COUNCIL ASSESSMENT REPORT
SYDNEY WESTERN CITY PLANNING PANEL

PANEL REFERENCE & DA NUMBER	PPSSWC-559 DA-585/2019/C
PROPOSAL	Modification to Development Consent DA-585/2019 for changes to the approved building envelope
ADDRESS	40-52 Scott Street Liverpool NSW 2170 LOT 1 DP 1293937
APPLICANT	BUILT Group
OWNER	Liverpool City Council
DA LODGEMENT DATE	14 May 2025
APPLICATION TYPE	S.4.55 Modification Application
REGIONALLY SIGNIFICANT CRITERIA	Schedule 6 of <i>State Environmental Planning Policy (Planning Systems) 2021</i> including both: Section 2- Development that has an estimated development cost of more than \$30 million; and Section 3 - Development for a Council related development with an estimated development cost of over \$5 million.
CIV	\$164,812,499.00 (excluding GST)
CLAUSE 4.6 REQUESTS	N/A
KEY SEPP/LEP	Environmental Planning Instruments State Environmental Planning Policy (Resilience and Hazards) 2021 State Environmental Planning Policy (Transport and Infrastructure) 2021 State Environmental Planning Policy (Biodiversity and Conservation) 2021 Liverpool LEP 2008 Development Control Plans Liverpool Development Control Plan 2008 <ul style="list-style-type: none">Part 4 – Devel

Figure 8: Amended envelope plan with proposed modification shown in red cloud

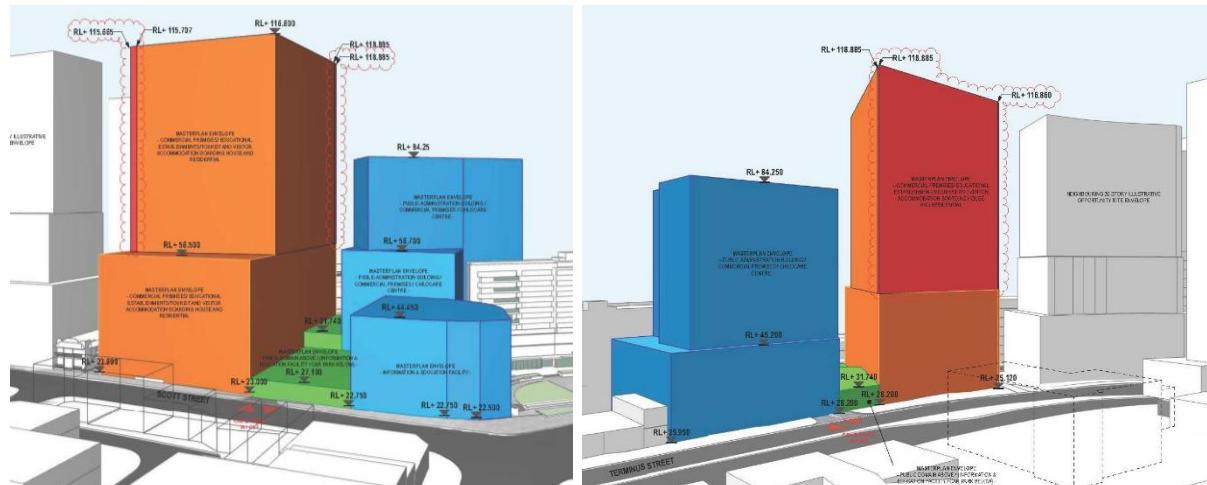
The proposed modification is to extend the approved Phase B tower building footprint / envelope on its southern and eastern sides. This includes an extension of the tower building envelope 1.952 m to the east toward George Lane and 2.1 m to the south toward Terminus Street.

The proposed extension to the eastern and southern sides of the Phase B tower building envelope will result in new tower setbacks above podium along Terminus Street and George Lane as shown in the table below:

The proposed modification to remove the tower setback on its southern side and reduce the tower setback on its eastern side has potential for a building at the approved height to have an imposing visual bulk and scale particularly at ground level, and affect the cohesiveness of the design relationship with Phase A buildings. The visual bulk of the building and its design relationship with surrounding buildings will depend on the detailed building design in a future DA. A condition of consent (Condition 35) is therefore recommended to require an urban design study be prepared that addresses these built form considerations in a DA for the detailed design of the Phase B building.

Figure 9: Amended envelope perspective from north (left) and south (right) with proposed modification shown in red cloud

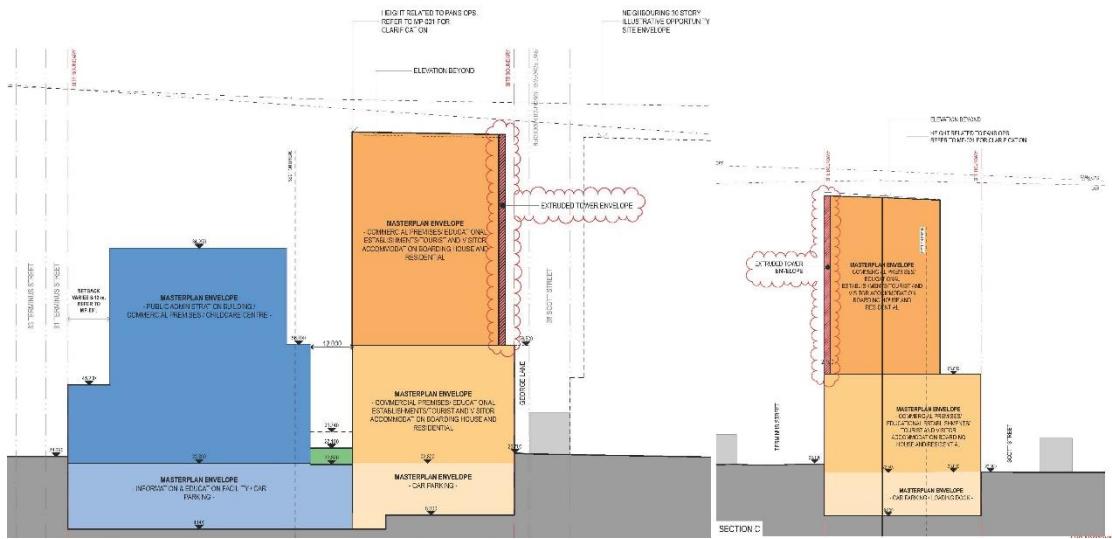
The proposed modification to remove the tower setback above podium along the Terminus Street elevation and reduce the tower setback above podium along the George Lane elevation, can have adverse wind impacts on the public domain on ground level from wind shear / deflection down these building elevations all the way to ground level without being disrupted and mitigated by a podium roof terrace level. The wind conditions in the public domain at ground level will depend on the detailed design of the Phase B development and any wind mitigation measures included in it.

The proposed removal and reduction of Phase B tower building setbacks above podium on the southern and eastern sides respectively raises the potential for the building at the approved height to have an excessive visual bulk and scale in the pedestrian and public domain at ground level. This will depend on the detailed design of the Phase B building in a future DA. A condition of consent (Condition 35) is recommended requiring an urban design study be prepared that addresses pedestrian scale in the public domain on ground level as part of a future DA for detailed design of the Phase B development.

Figure 10: Amended sections with proposed modification shown in red cloud

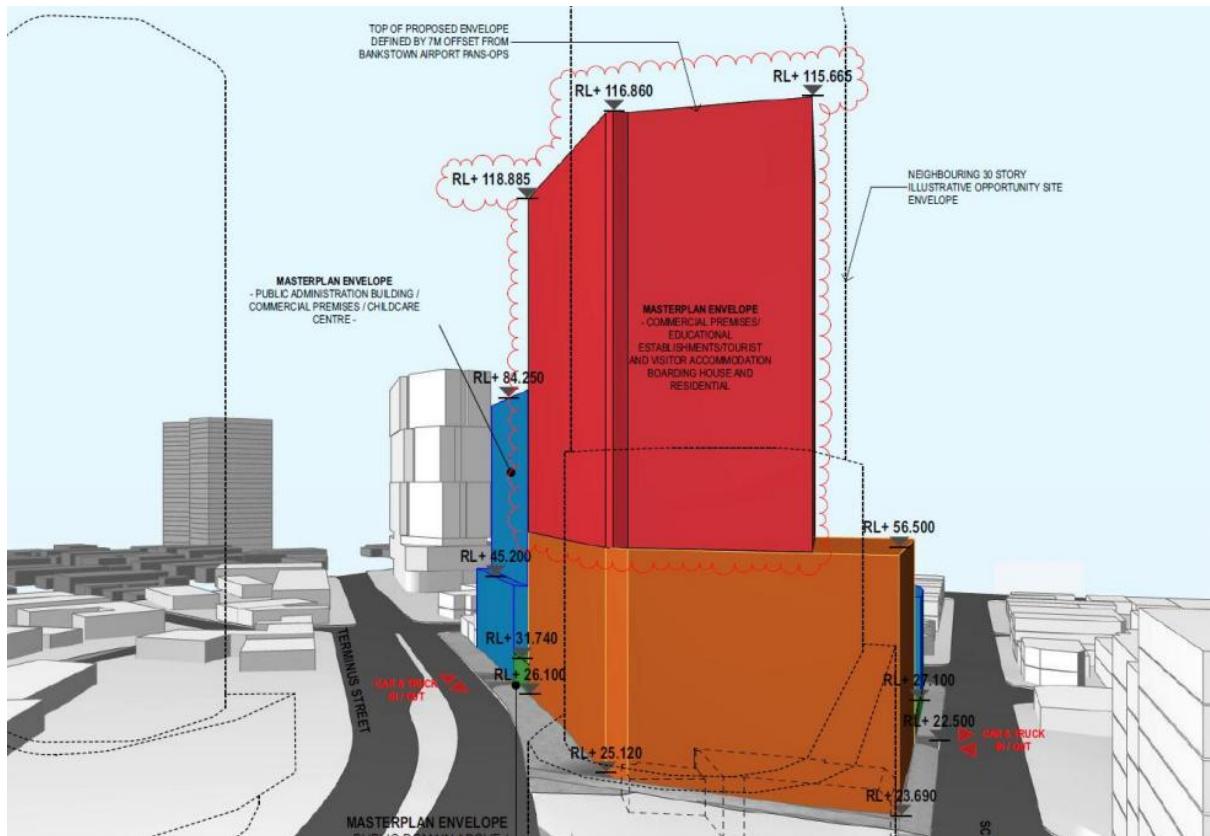
The proposed modification seeks to extend the Phase B building tower envelope east toward George Lane by 1.952m and thereby reducing its separation distance to approximately 6.5m to the boundary of the property to the east on the opposite side of George Lane.

The proposed extension of the Phase B tower envelope by 1.952m to the east has potential to impact sunlight and daylight access in the public domain in George Lane. It would have no impact on solar access in any other significant public domain area, any existing residential property, or any future residential development to the north, east or west. It would have minimal to negligible impact on solar access in any future residential development to the south on the opposite side of Terminus Street. A condition of consent (Condition 35) is recommended to require an urban design study be prepared that addresses sunlight and daylight access in George Lane in a DA for the detailed design of the Phase B building.
